# TRAVEO™ T2G CYT2B6 errata sheet

## Marking/Step: Rev. D

32-bit single-chip microcontroller

Figure 2 CAN frame with  $DLC > 4$

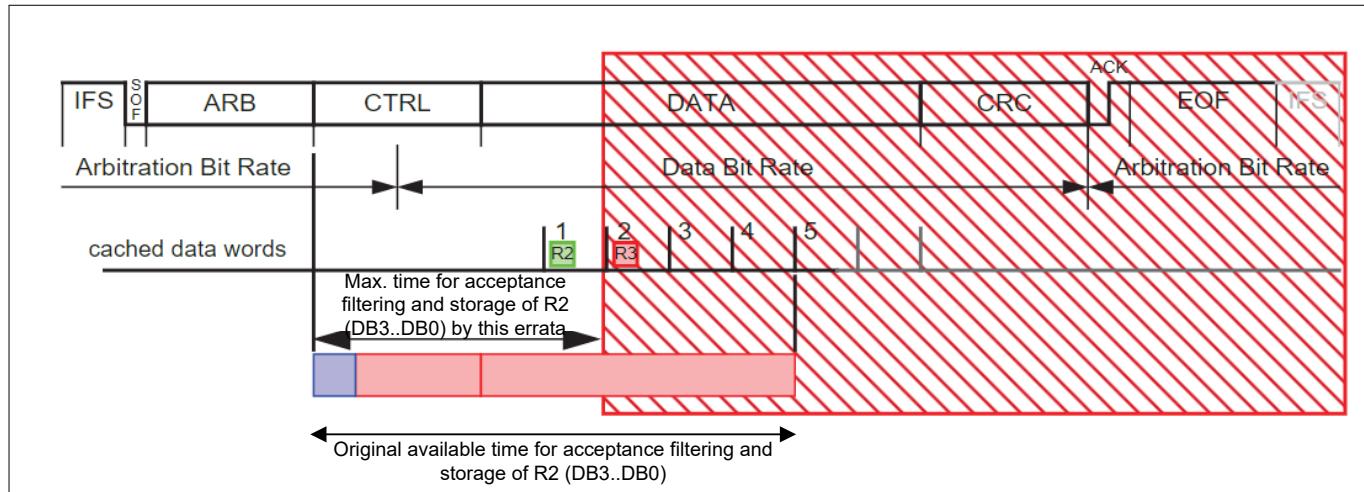
The issue may occur in FD Frame Format as well as in Classic Frame Format.

Figure 2 shows how the available time for acceptance filtering and storage is reduced.

Due to condition 3 the issue occurs only sporadically. Use an end-to-end (E2E) protection (for example, checksum or CRC covering the data field) and add it to all messages in the CAN system, to detect data corruption in received frames.
